DEVELOPMENT APPLICATION ASSESSMENT REPORT

Application Number:	DA2022/1820

Responsible Officer:	Gareth David
Land to be developed (Address):	Lot 342 DP 12316, 11 Kimo Street NORTH BALGOWLAH NSW 2093
Proposed Development:	Demolition of existing sites & construction of a dwelling house on Lot 342
Zoning:	Warringah LEP2011 - Land zoned R2 Low Density Residential
Development Permissible:	Yes
Existing Use Rights:	No
Consent Authority:	Northern Beaches Council
Land and Environment Court Action:	No
Owner:	Laurence John Bilsborough
Applicant:	PCL & APR Pty Ltd

Figure 1: Side boundary envelope breach on the northern elevation shown in pink

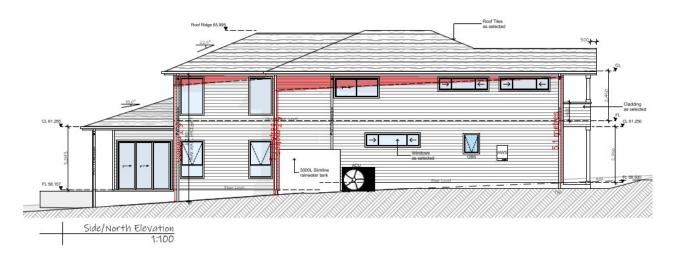
Clause B3 of the WDCP 2011 stipulates that buildings are to be projected at 45 degrees from 4m above the existing ground level, measured from the side boundaries. The proposed dwelling additions encroach into the side boundary envelope along the northern and southern elevations as depicted in figures 1 and 2 below.

Figure 2: Side boundary envelope breach on the southern elevation shown in pink

It should be noted during the assessment of this application, amended plans were received which reduced the extent of the non-compliance on the northern elevation.
